# Harbour Quays

Developed Design Stage Safe System Audit

Prepared for:  
Wellington City Council

Prepared by:  
Stantec

Figure 5-1: View of proposed Bus Lane markings near Brandon Street

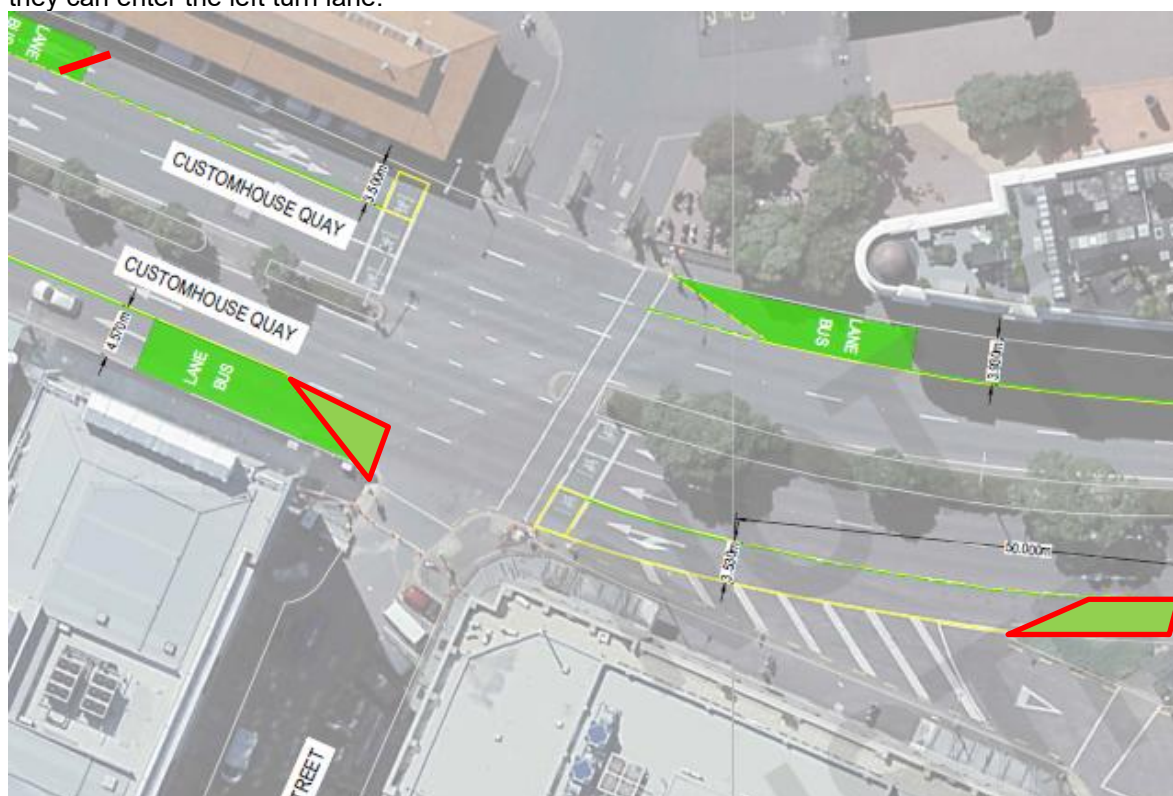
As Brandon Street is one way westbound, there will not be any vehicles exiting Brandon Street onto Customhouse Quay. Therefore, there is no need to provide taper markings on the bus lane markings.

Additionally, for southbound motorists' intent on turning left into the harbourside/wharf area, there should be a sloping taper to indicate to motorists where they can enter the bus lane in order to turn left.

Similarly for motorists exiting left onto Jervois Quay from Customhouse Quay, there needs to be a taper and bus lane marking provided so that it is clear to motorists both exiting from Customhouse Quay as well as those already on Jervois Quay and wanting to turn left into Brandon Street where they can enter the left turn lane.

1. Remove the proposed taper from the Bus Lane road markings immediately north of Brandon Street.
2. Provide a taper on the bus lane marking for southbound motorists so that it is clear to left turning motorists where they can enter the left turn lane.
3. Provide a bus lane marking with taper for northbound motorists in advance of the Customhouse Quay intersection with Jervois Quay so that it is clear to motorists' both on Jervois Quay and those exiting Customhouse Quay onto Jervois Quay where they can enter the left turn lane to access Brandon Street.

Design team response	Agreed – bus lane plan will be amended as per recommendations
Client safety engineer comment	Agree with Designer response.
Client decision	Progress designer response in detailed design.
Action taken	Bus lane to be amended during detailed design.

Figure 5-4: View of proposed Bus Lane markings northbound on Wakefield Street prior to Taranaki Street

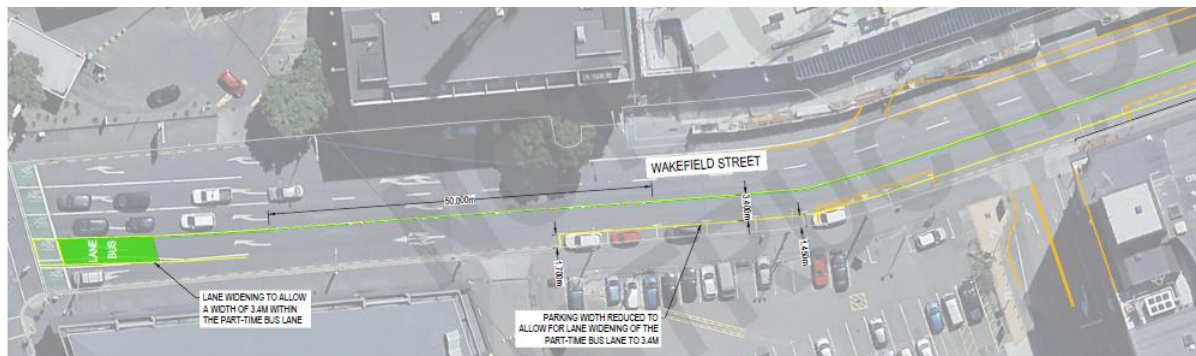
The northbound bus lane in advance of Taranaki Street is currently not provided with a bus lane marking with taper to indicate to left turning motorists where they are permitted to enter the left lane in order to turn left into Taranaki Street.

1. Provide a bus lane marking with taper northbound prior to Taranaki Street to indicate to left turning motorists where they can enter the left lane in order to access the left turn lane.

Design team response	Agreed – bus lane plan to be amended as per recommendation.
Client safety engineer comment	Agree with Designer response.
Client decision	Progress designer response in detailed design
Action taken	Bus lane to be amended during detailed design.

Figure 5-5: View of proposed Bus Lane markings on approach to Tory Street

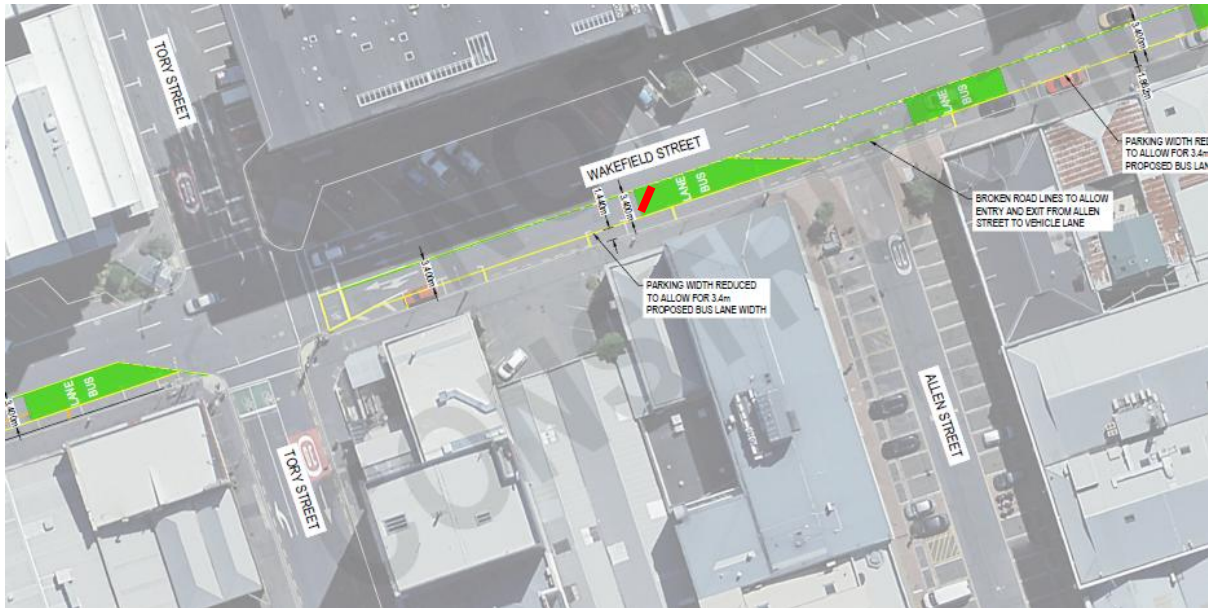
The northbound Wakefield Road approach to Tory Street does not have a sloping entry marking on the proposed bus lane markings to indicate to left turning motorists where they should enter the bus lane in order to turn left into Tory Street (refer red bar in Figure 5-5 below).

1. Taper the end of the bus lane marking to indicate to motorists where they are permitted to enter the left lane in order to turn left at Tory Street.

Design team response	Agreed – bus lane plan to be amended as per recommendation
Client safety engineer comment	Agree with Designer response.
Client decision	Progress designer response in detailed design
Action taken	Bus lane to be amended during detailed design.

Figure 5-7: View of proposed layout near Ballance Street

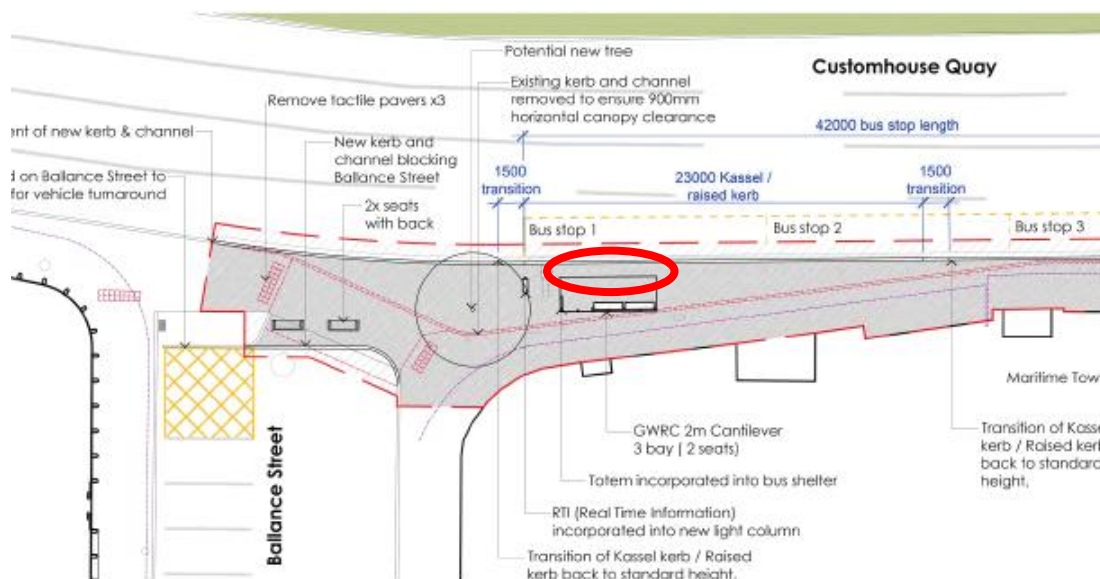
The proposed bus shelter is located in close proximity to the new kerb and channel which provides minimal manoeuvring space for bus patrons to access the first bus at the bus stop. There is sufficient space in this area to increase the available footpath width in front of the proposed bus shelter.

Additionally, whilst on site the SAT observed a motorist attempt to exit from Ballance Street into Customhouse Quay. This manoeuvre increases the risk of collision with a driver turning left from Customhouse Quay into Ballance Street at this location. Whilst in the proposed plans Ballance Street will become a cul-de-sac, in the interim this risk remains. As such the provision of appropriate signage to direct drivers away from exiting onto Customhouse Quay from Ballance Street should be considered.

1. Maximise the footpath width between the proposed bus shelter and the new kerb and channel.
2. Provide appropriate signage to stop drivers exiting Ballance Street onto Customhouse Quay.

Design team response	Agree with recommendation 1 – we will investigate opportunities to provide additional footpath width at this stop location. Agree with recommendation 2 – noting that the obligation to provide appropriate signage for the existing intersection should not form part of the Harbour Quays project
Client safety engineer comment	Agree with Designer responses, notwithstanding the necessary signage should be shown in the Harbour Quays Project design.
Client decision	Recommendation 1 – This will be assessed during detailed design Recommendation 2 – To be handed over to maintenance
Action taken	Recommendation 1 – This will be assessed during detailed design Recommendation 2 – To be handed over to maintenance

Figure 5-8: View of blocked drain (left). Plan with red circle indicating location of drain.

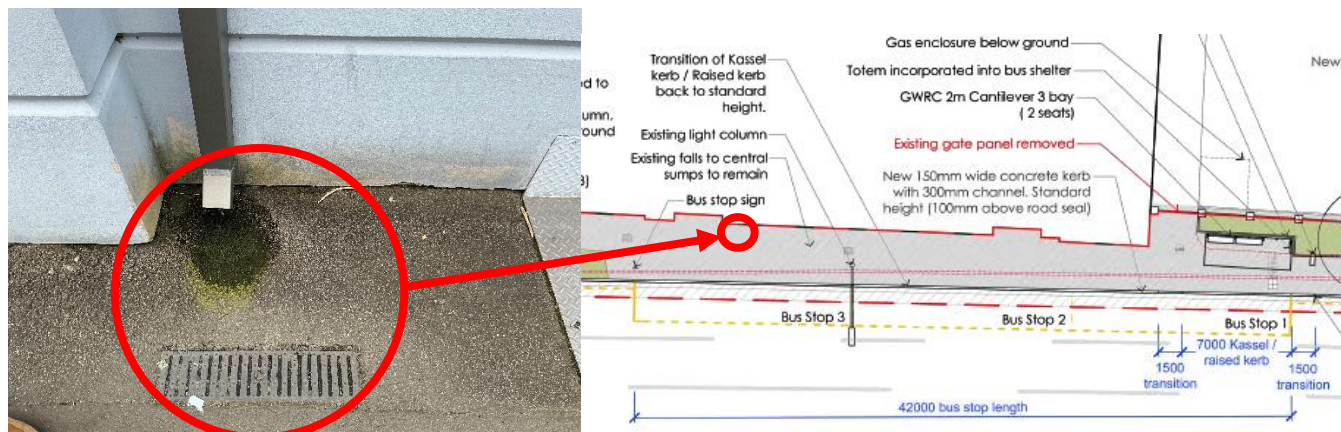
There is a downpipe which does not connect directly into the drain with the stormwater discharging directly onto the footpath prior to entering a nearby drain (refer to Figure 5-9 below). However, the drain appears to be partially blocked which would result in water covering the footpath in heavy rainfall events, increasing the risk of slips, trips and falls when this footpath becomes a route to the proposed bus stop.

1. Address the downpipe / drainage grill connection to ensure that the footpath does not create a slip hazard in heavy rainfall events.
2. Request drainage maintenance team review the timing of drainage sump / grill maintenance.

Design team response	Agree with observed issue – it is recommended that the blocked drain be reported to an appropriate maintenance group for resolution.
Client safety engineer comment	Agree with Designer response. Refer to Maintenance and Renewals
Client decision	Agree with designer response, to be referred to be maintenance and renewals.
Action taken	To be handed over to Maintenance to address.

Figure 5-9: View of proposed layout at Post Office Square proposed Bus Stop. Red circle indicates position of existing parking meter.

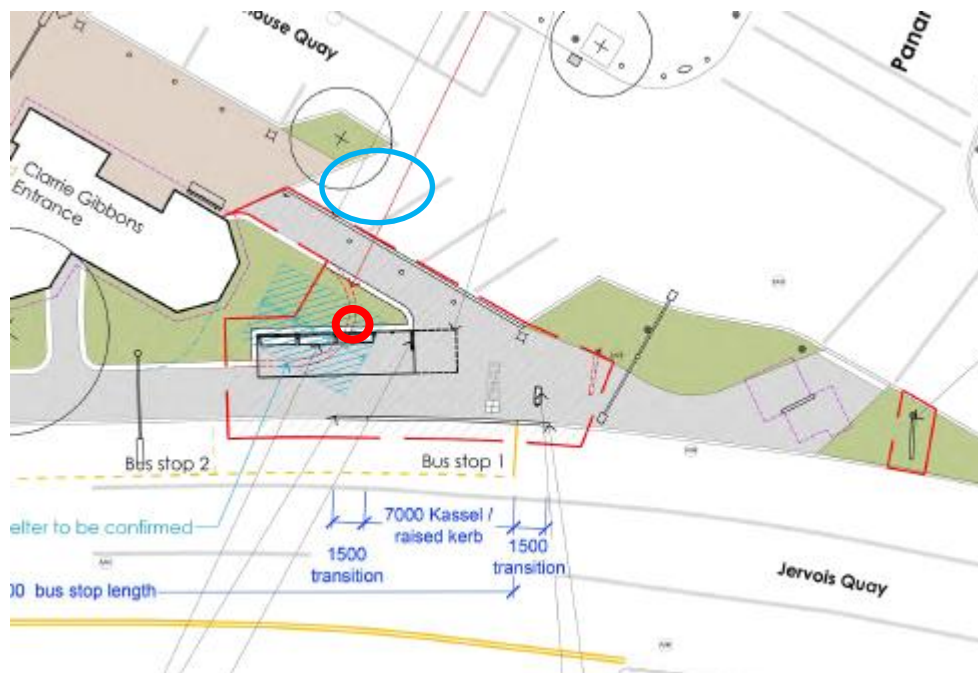
There is an existing parking meter located near the red circle (refer to Figure 5-9 below) which is not shown on the current plans. This was previously raised in the concept design audit report. The SAT were also advised that due to root interference, there is the potential for the carpark circled in blue (refer to Figure 5-9 below) to be removed.

1. Ensure that that the existing parking meter is relocated in close proximity to the existing parking spaces.

Design team response	Agree – existing parking meter will be relocated closer to car parks, subject to confirmation of retention of parking by cross city project.
Client safety engineer comment	Agree with Designer response.
Client decision	Agree with designer response
Action taken	Final location of parking meter to be addressed during detailed design.
